**CALIFORNIA COASTAL COMMISSION**

**SUBJECT: STAFF RECOMMENDATION ON CITY OF SAN DIEGO MAJOR  
AMENDMENT 3-03C (Sunset Pointe) for Commission Meeting of  
June 7-10, 2005**

The City of San Diego is requesting to amend both the certified North City LCP Land Use Plan (LUP) segment (Mira Mesa subarea) and the certified LCP Implementation Plan (IP). The proposed LCP amendment would change the current boundaries between the residential and open space land use designations on a 37.5 acre site (one legal parcel)

# Land Use Map

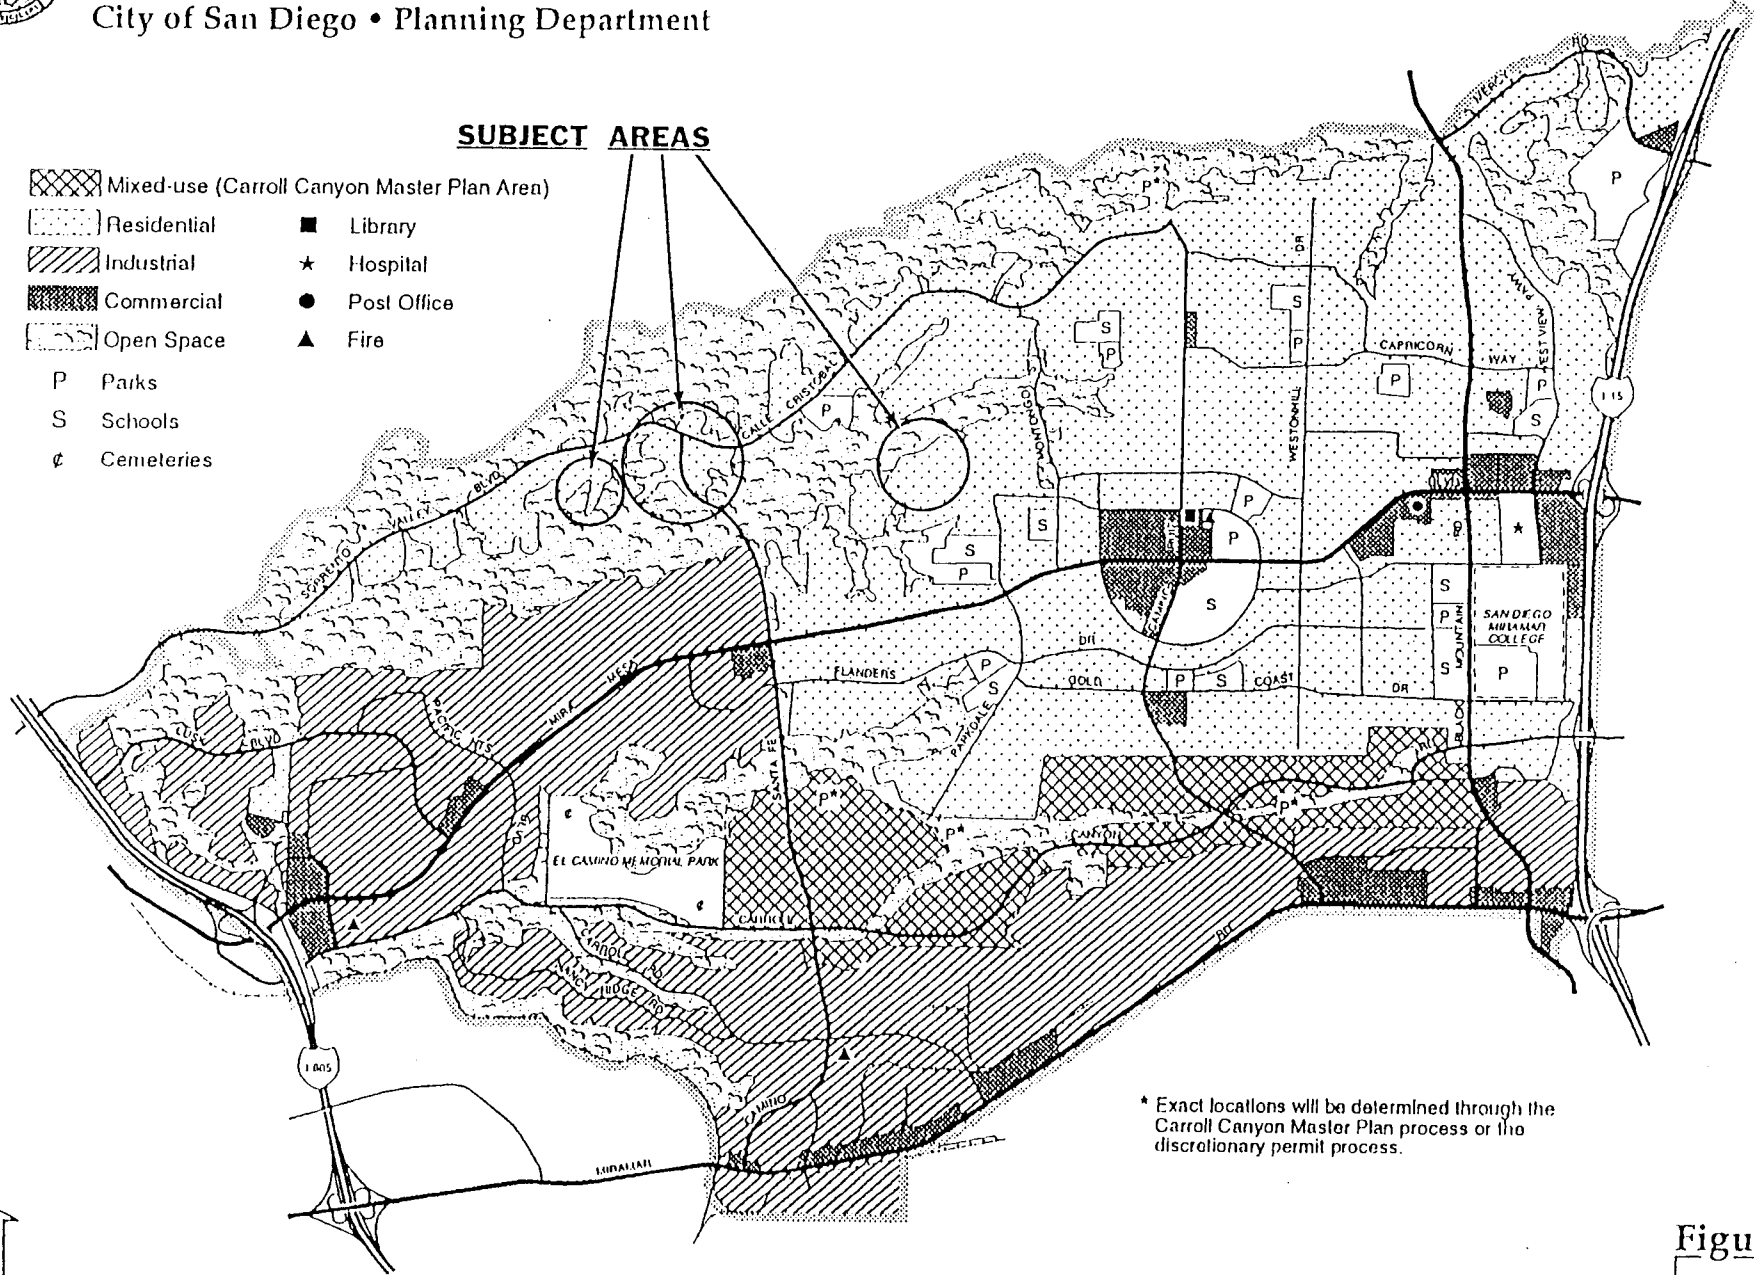
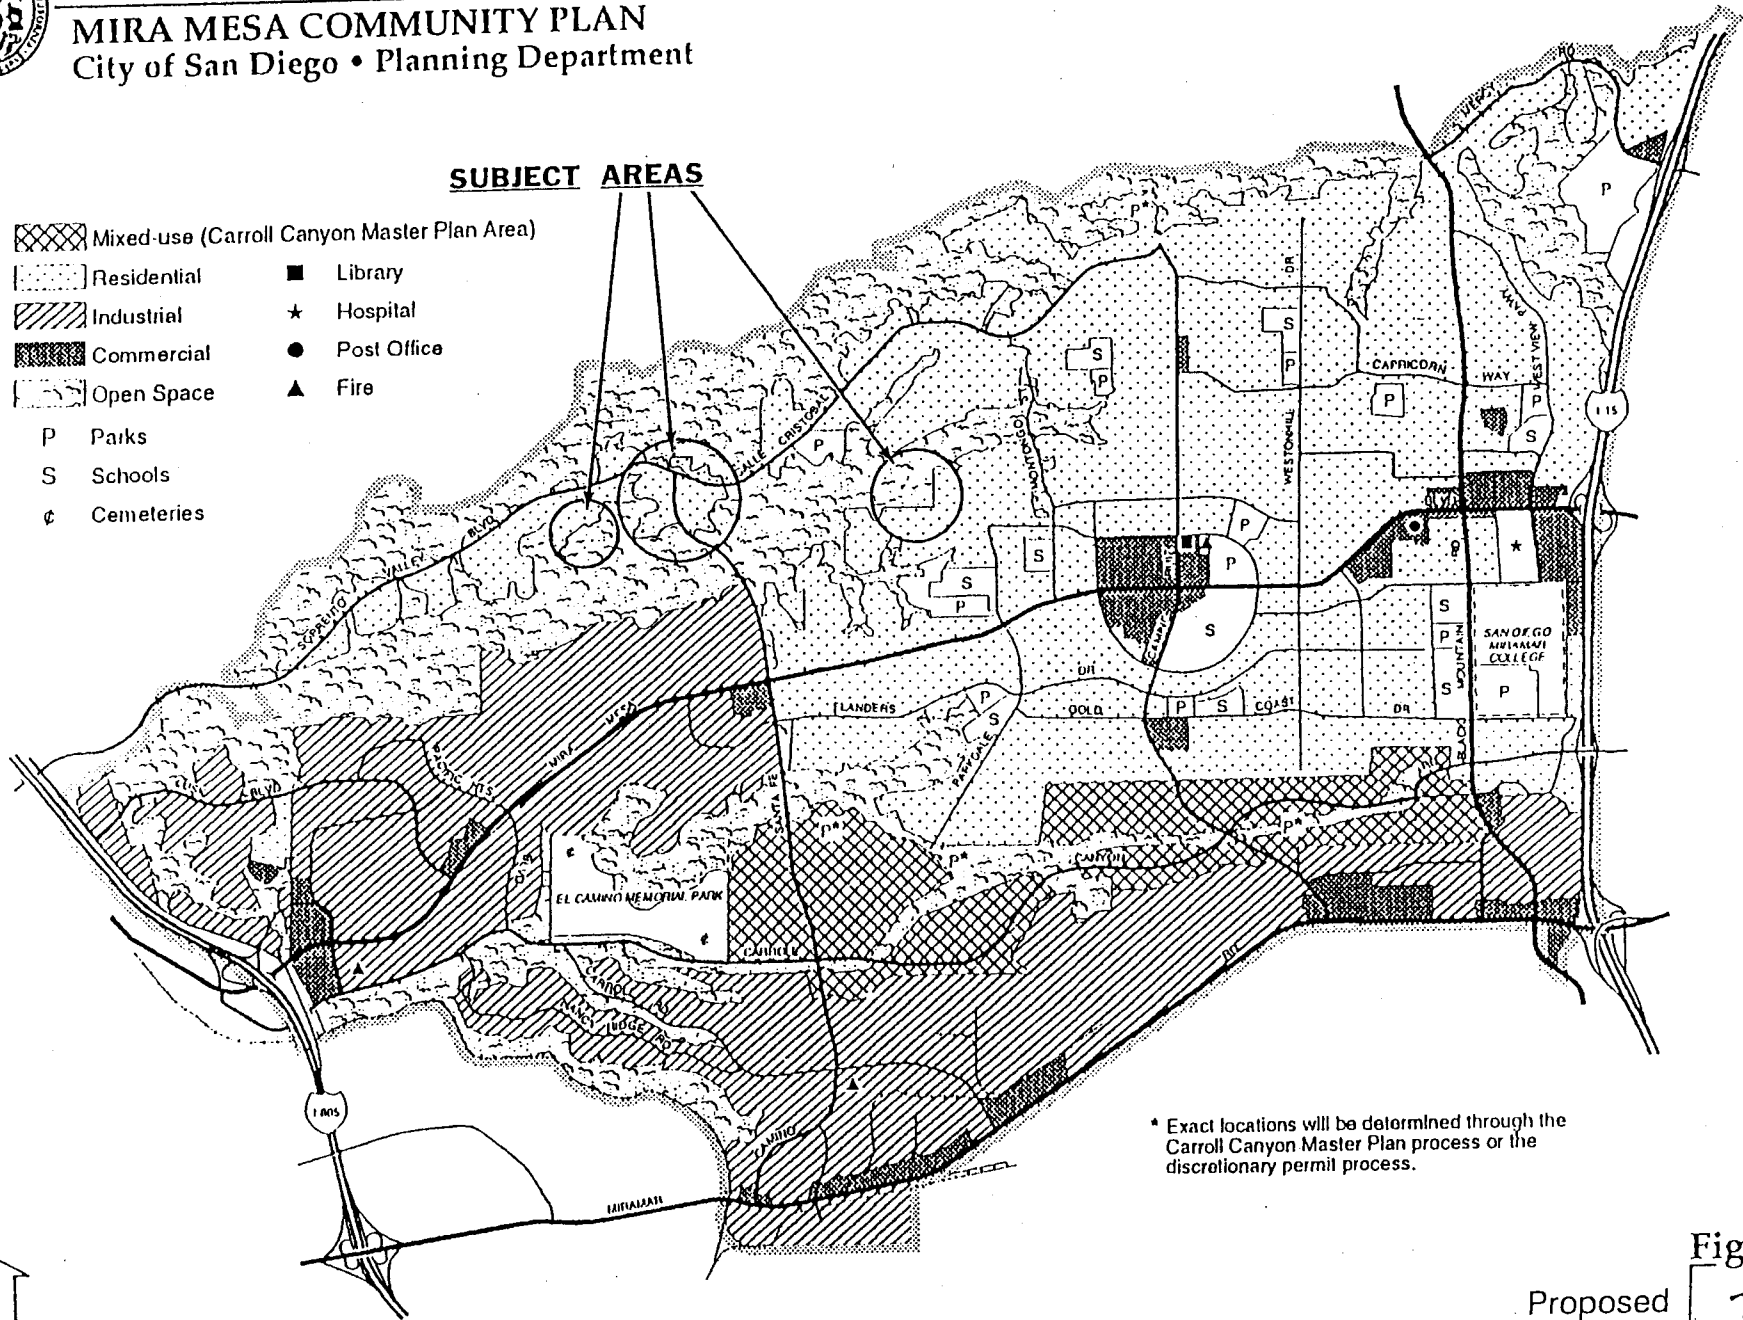
1. Revise the proposed Figure 1 (Land Use Map), Figure 6 (Designated Open Space System), Figure 7 (Recommended Trail System), Figure 8 (Recommended Wildlife Corridors) and Figure 18 (Recommended Residential Densities) to conform to the revised boundaries between open space and residential developable area as shown on Exhibit 4, dated 3/14/05. The revised open space line generally follows the rimline, grading limit or the upper limits of the coastal sage scrub vegetation as shown on the exhibit titled Sunset Pointe – Vegetation with MHPA, Limits of Grading and Brush Management for Approved TM, using vegetation shown on the biological resources map (Figure 4C-2) in the certified EIR.

Suggested Modification #1 addresses corrections to several of the LUP maps. It requires revision of the identified maps to be fully consistent with the resources on-the-ground on the Sunset Pointe property. As proposed by the City, areas of sensitive habitats, including ESHA, would be included in the developable areas of the site. This cannot be found consistent with Section 30240 of the Coastal Act.

As modified and addressed in the revised map required by Suggested Modification #1, the Commission would allow changes to the open space boundary that would protect the high quality native grassland and coastal sage scrub (Tier I or Tier II) habitat on the Sunset Pointe property within the open space designation. The lower quality habitat and disturbed areas found on the western mesa would be designated for residential use. Access to the western mesa can be achieved from Sunny Mesa Road without encroaching into the high-quality coastal sage scrub slopes on the western wall of the finger canyon; however, some encroachment onto slopes in excess of 25% grade (steep hillsides in the ESL regulations) containing non-native grasslands and native vegetation within the residentially-designated portion of the property will be necessary to construct an access road serving the flatter portion of the mesa.

Suggested Modification #1 requires modification of the LUP maps such that all high quality native grasslands and coastal sage scrub identified as Polygons 6, 8, 9 and 10 by Natural Resource Consultants will remain protected, or, if not protected now, will become protected through the open space designation. The modification may also protect some less sensitive habitat which are on steep hillsides and contiguous with native grasslands and coastal sage scrub, which also perform important biological functions. The revised open space line generally follows the rimline or the upper limits of the coastal sage scrub vegetation and native grassland where non-ESHA vegetation extends beyond the rim line, as shown on the biological resources map shown and Figure 4C-2 in the certified EIR. In addition, any development of steep hillsides is still regulated by the ESL regulations of the LDC and the LUP policy prohibiting grading beyond the canyon rim. Brush management allowable within open space areas is addressed in Suggested
